Illinois Tollway Base Sheet Revisions			
Section M	Base Sheet Drawings		
	Drawing	Modification Summary	Effective: 2018-03-01
	Pole Assembly (ITS)-Series 1000		
M-ITS-1000	Elevation Views Pole Mounted ITS Element Assembly		
	Added disconnect switch detail sheet.		
	Minor editorial changes.		
	Dynamic Message Sign (ITS)-Series 1100		
M-ITS-1100	DMS Type 1 Electrical Plan		
	Minor editorial changes.		
M-ITS-1101	DMS Type 1 Site Grounding Plan		
	Minor editorial changes.		
M-ITS-1102	DMS Type 1 Typical Site Wiring Detail		
	Minor editorial changes		
M-ITS-1103	DMS Type 2-Cantilever Electrical Plan		
	Minor editorial changes.		
M-ITS-1104	DMS Type 2-Butterfly Electrical Plan		
	Minor editorial changes		
M-ITS-1105	DMS Type 2 Site Grounding Plan		
	Clarified coarse wash gravel specifications.		
	Minor editorial changes.		
M-ITS-1106	DMS Type 2 Site Wiring Details		
	Minor editorial changes		
M-ITS-1107	DMS Cabinet Layout Detail

RWIS POLE, SENSOR MOUNTING DETAIL (SHEET 2 OF 2)

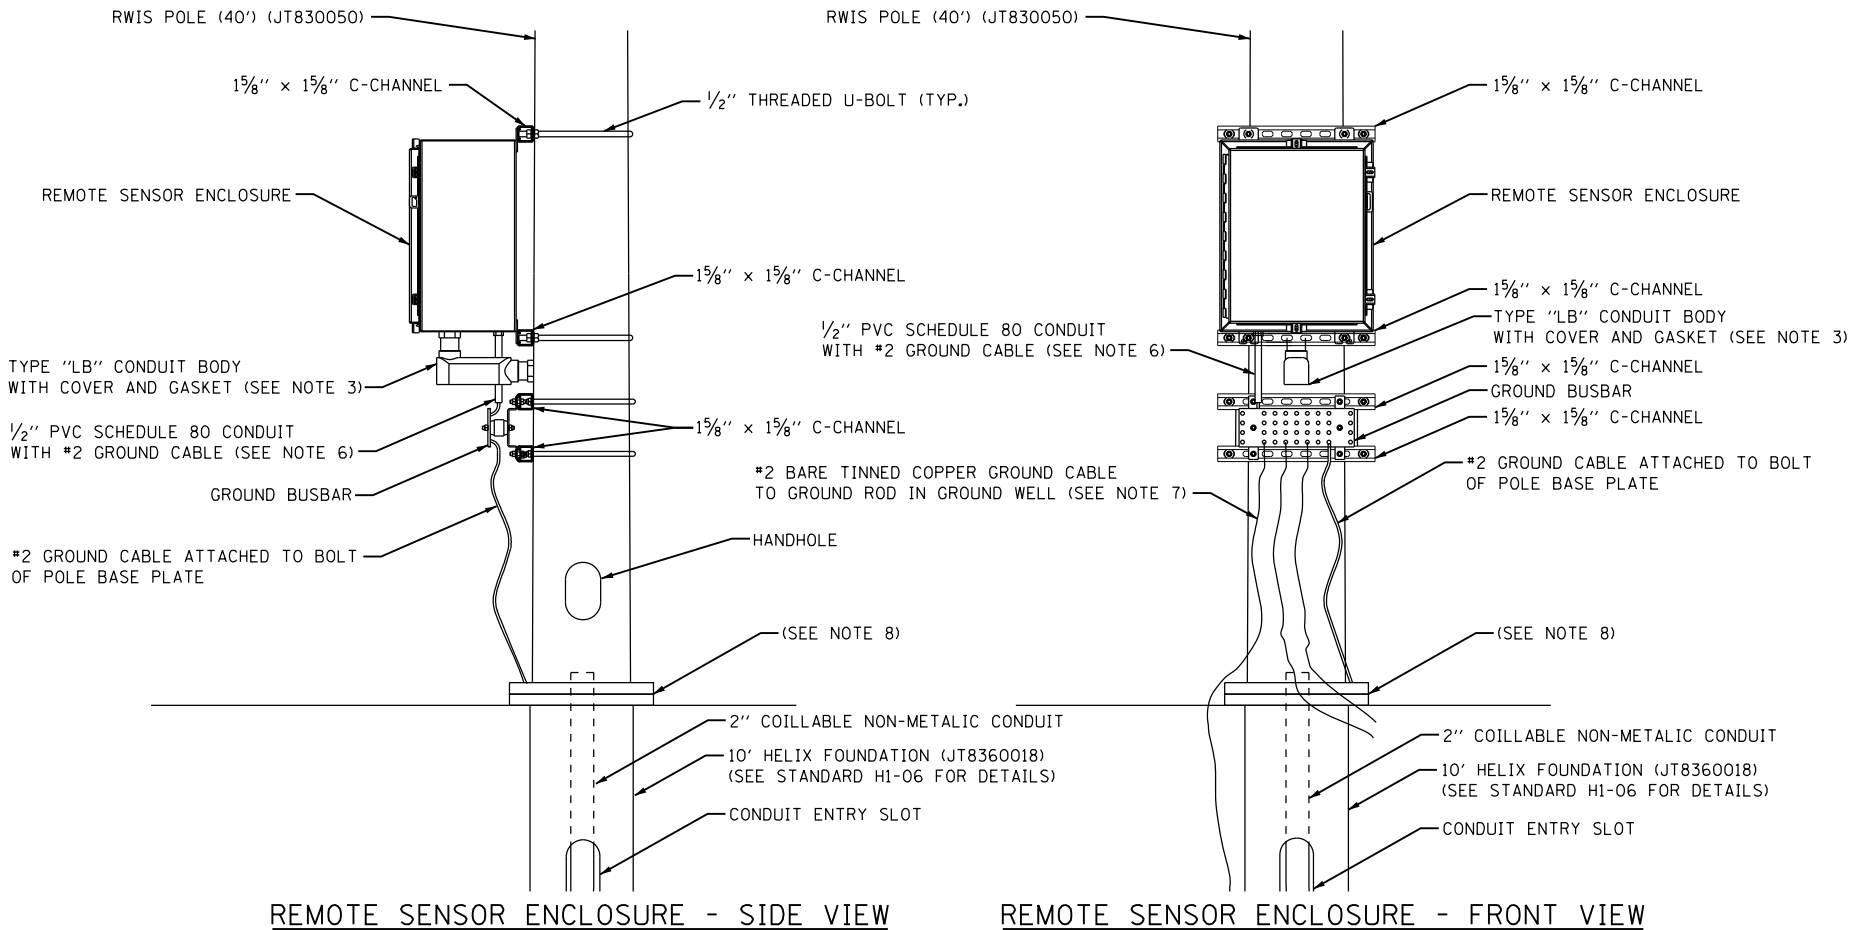
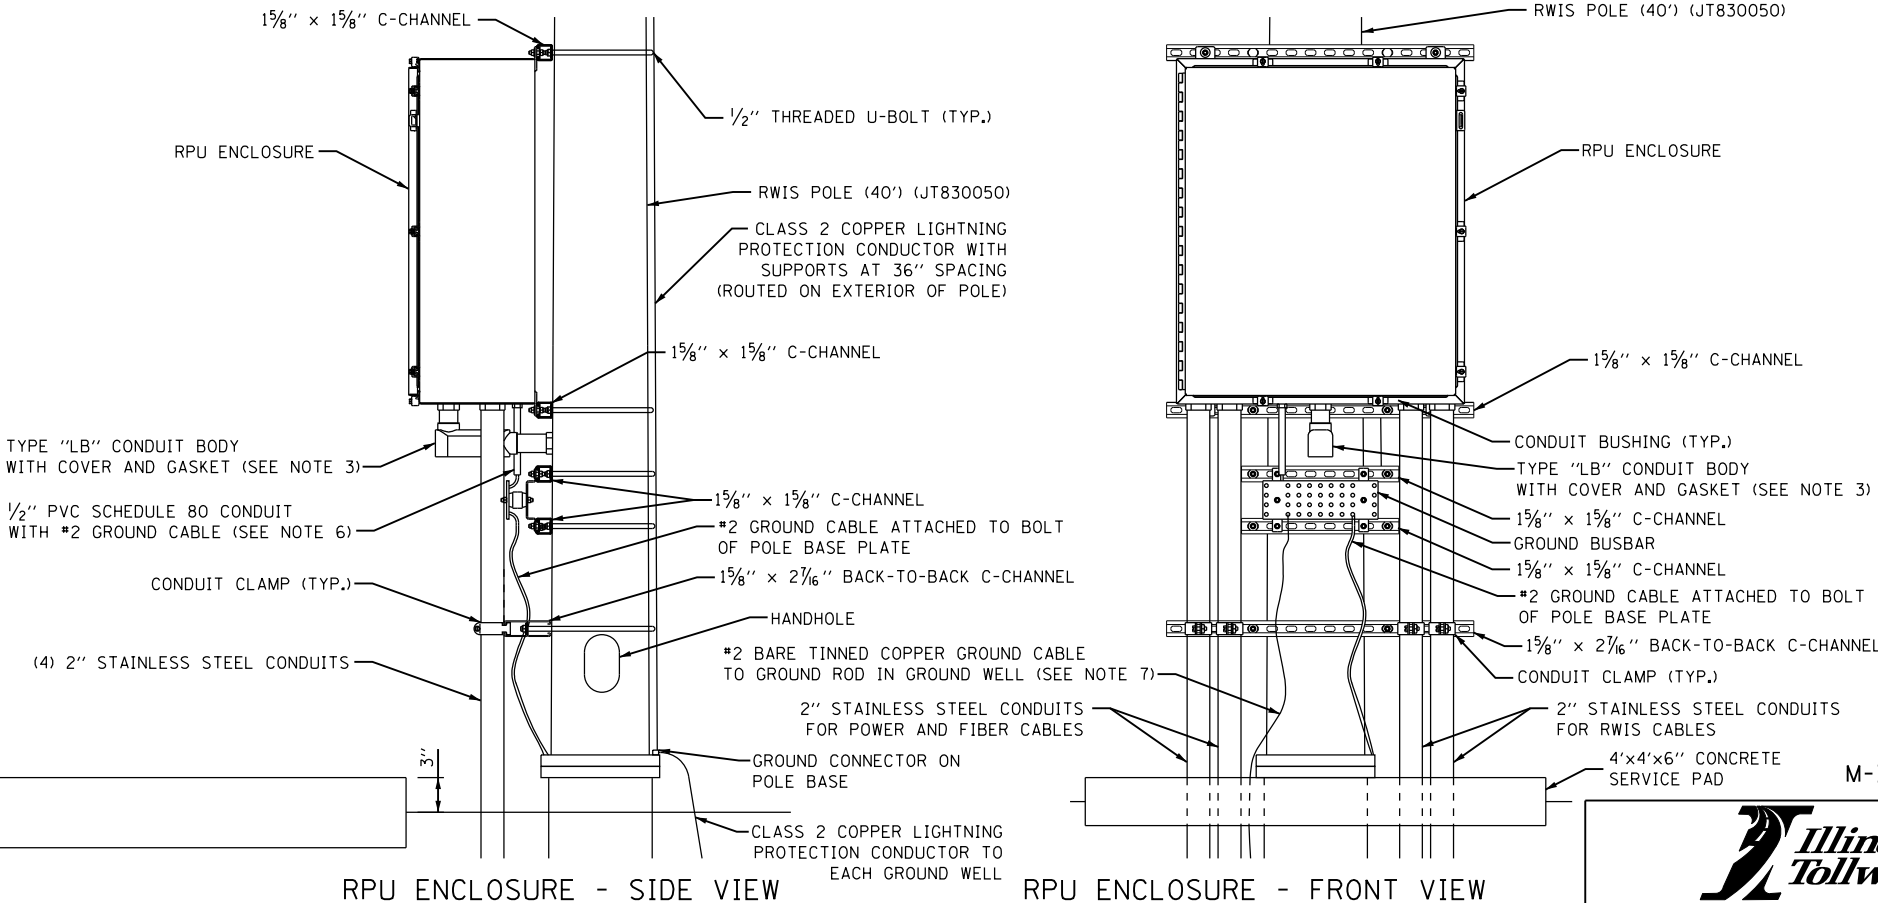
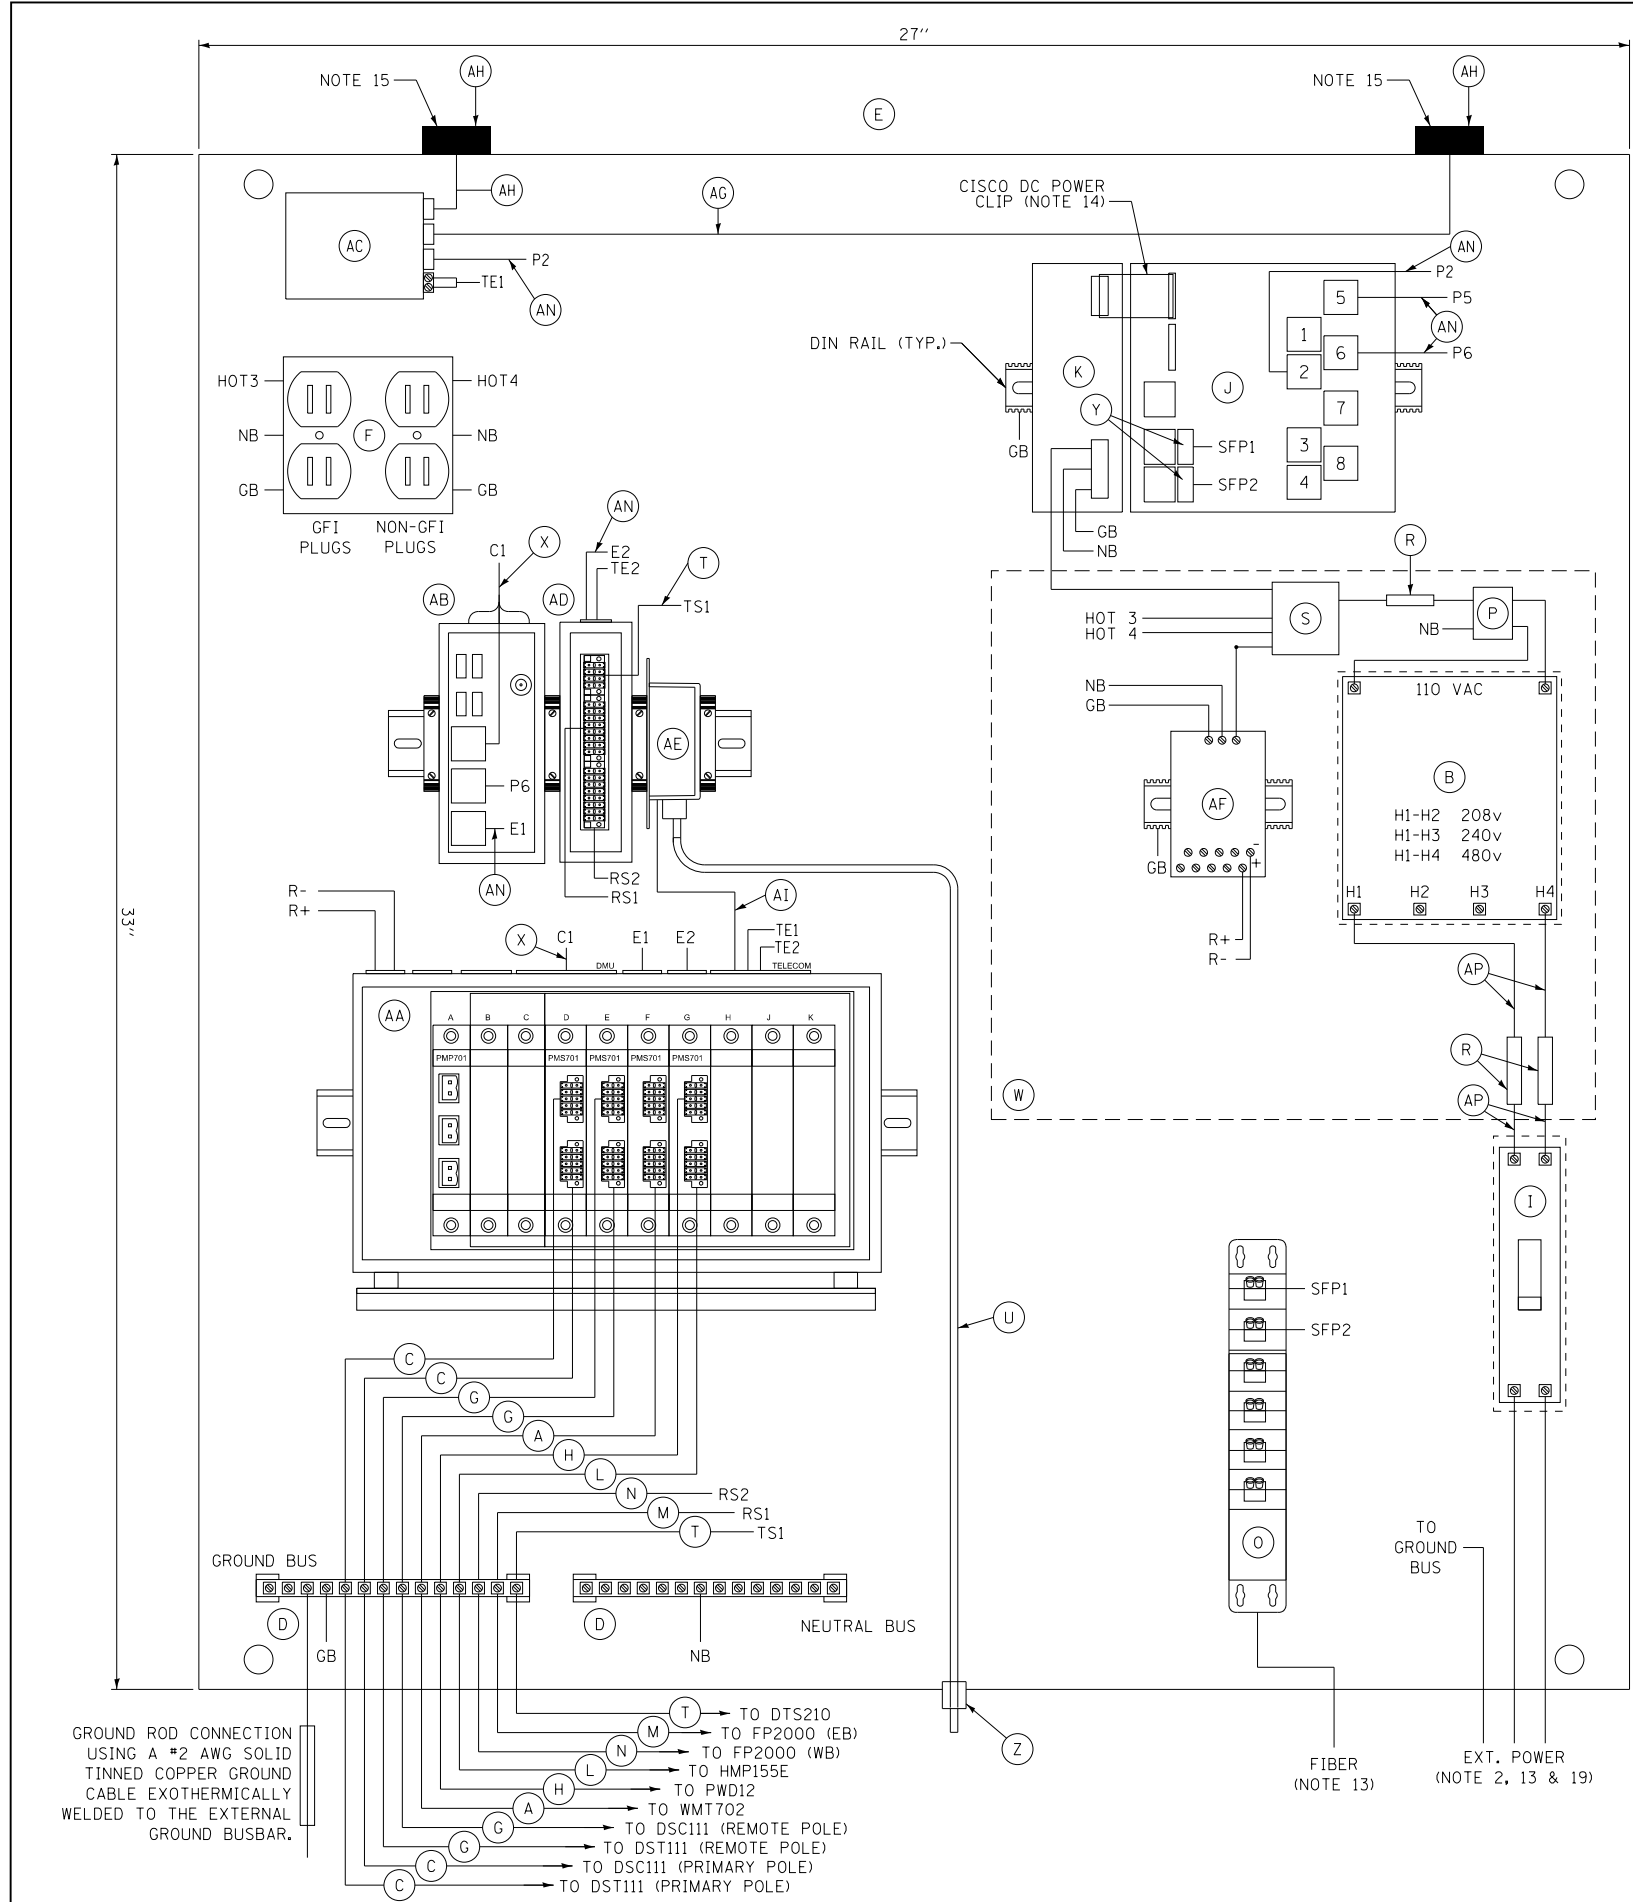
Minor editorial changes.		
M-ITS-1108	DMS Cabinet Wiring Diagram		
	Minor editorial changes.		
	Cabinet Wiring (ITS)-Series 1200		
M-ITS-1200 to M-ITS-1255	Cabinet Wiring Diagrams		
	Revised DIN3 IP relay to DIN4.		
M-ITS-1200 to M-ITS-1207, M-ITS-1210, M-ITS-1255	Cabinet Wiring Diagrams		
	Added single mode fiber patch panel.		
M-ITS-1200 to M-ITS-1202, M-ITS-1223 to M-ITS-1254	Cabinet Wiring Diagrams		
	Added power over ethernet injector(s).		
M-ITS-1200	ITS Pole Mounted Enclosure (CCTV and MVDS)		
	Added second sheet showing scale layout.		
M-ITS-1203 to M-ITS-1205, M-ITS-1211 to M-ITS-1222, M-ITS-1231 to M-ITS-1254	Cabinet Wiring Diagrams		
	Clarified MVDS wiring.		
M-ITS-1256	Tower Mounted CCTV ITS Assembly, 300' CAT6 or Less		
	Retired.		
	Roadway Weather Information System (ITS)-Series 1300		
M-ITS-1300	RWIS Pole, Sensor Mounting Detail

Sheet redrawn with new pole-mounted RWIS design		
M-ITS-1301	RWIS Cabinet Wiring Diagram		
	Sheet redrawn with new pole-mounted RWIS design.		
	RWIS connected to fiber.		
M-ITS-1302	Typical RWIS Site Installation Plan

TYPICAL RWIS SITE
INSTALLATION PLAN
(SHEET 1 OF 2)

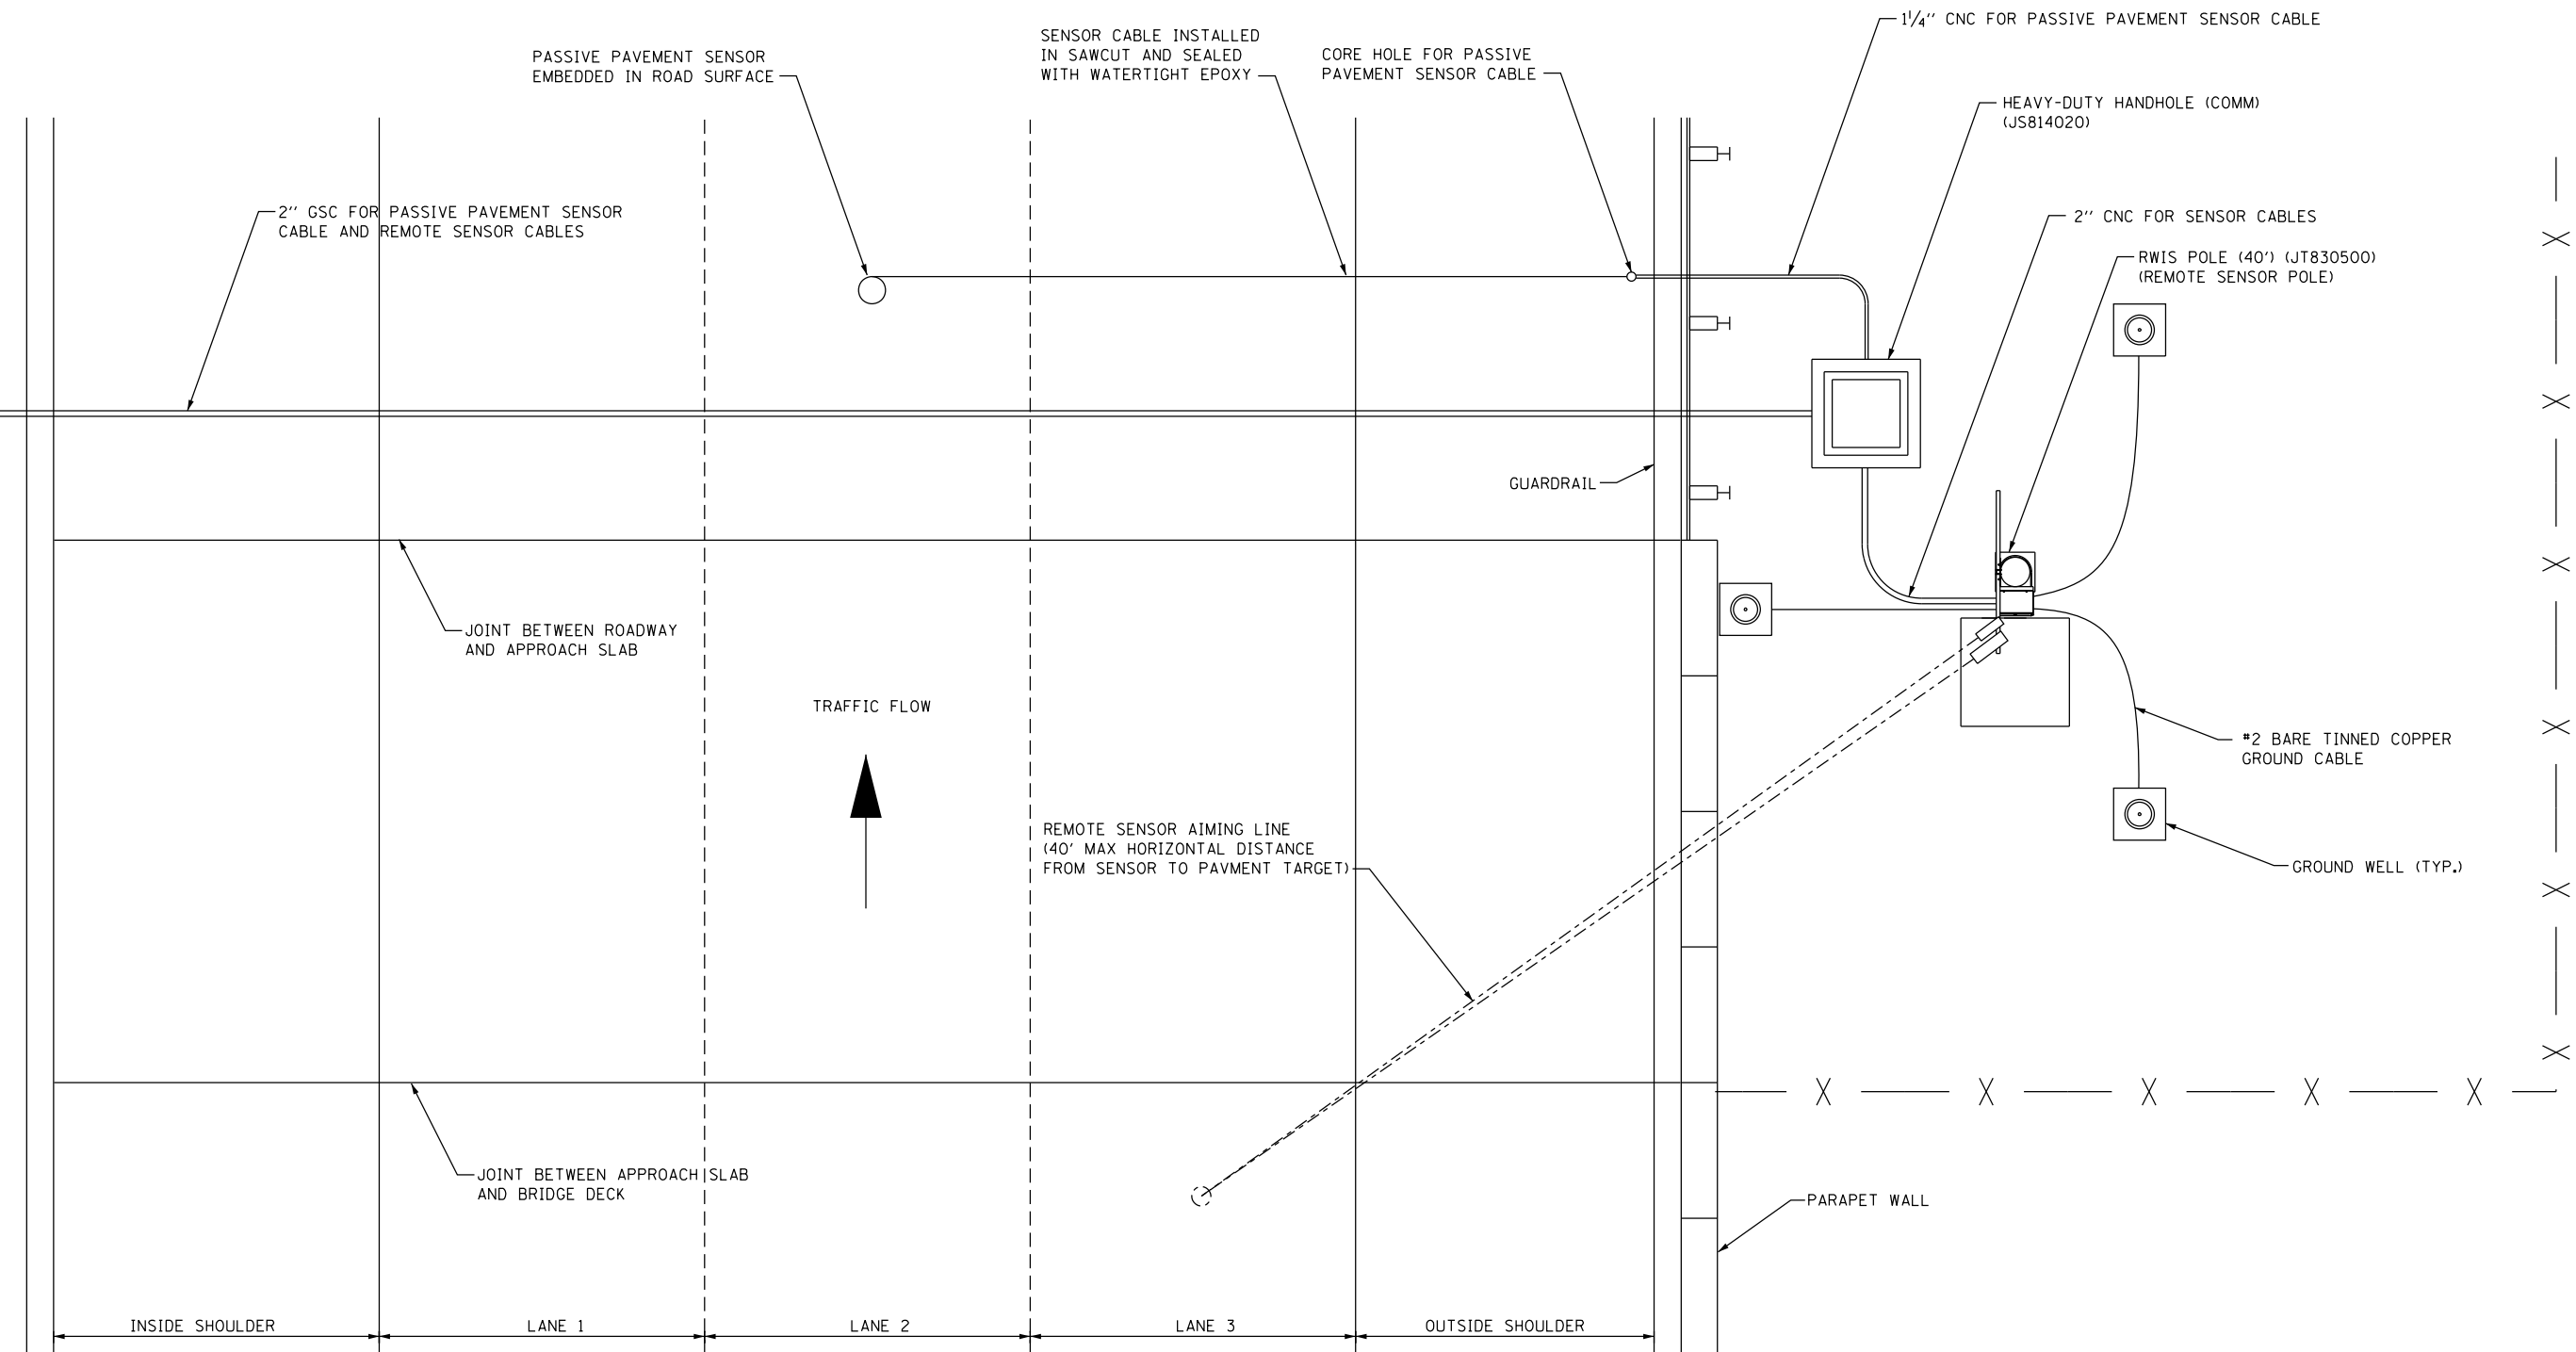
Sheet redrawn with new pole-mounted RWIS design.		
	Added non-intrusive pavement sensor.		
M-ITS-1303	RWIS Road Surface Sensor Pole		
	Retired.		
	Tower Mounted CCTV (ITS)-Series 1500		
M-ITS-1502	ITS Details Tower Mount Camera Assembly		
	Reference to M-ITS-1256 changed to M-ITS-1255 to reflect changes in 1200 series.		
	Plaza Electrical (Business System)-Series 2500		
M-BUS-2501	Legend, Symbol List, Abbreviations and Equipment Schedules		
	Minor editorial changes.		
M-BUS-2525	I-Pass Only (IPO) Lane Island Plan and Details 12 Foot Wide Lane		
	Minor editorial changes.		
M-BUS-2526	Toll Equipment Wiring Diagram ACM and IPO Lanes		
	Minor editorial changes.		
M-BUS-2558	VES Wash System Suggested Conduit Routing		
	Minor editorial changes.
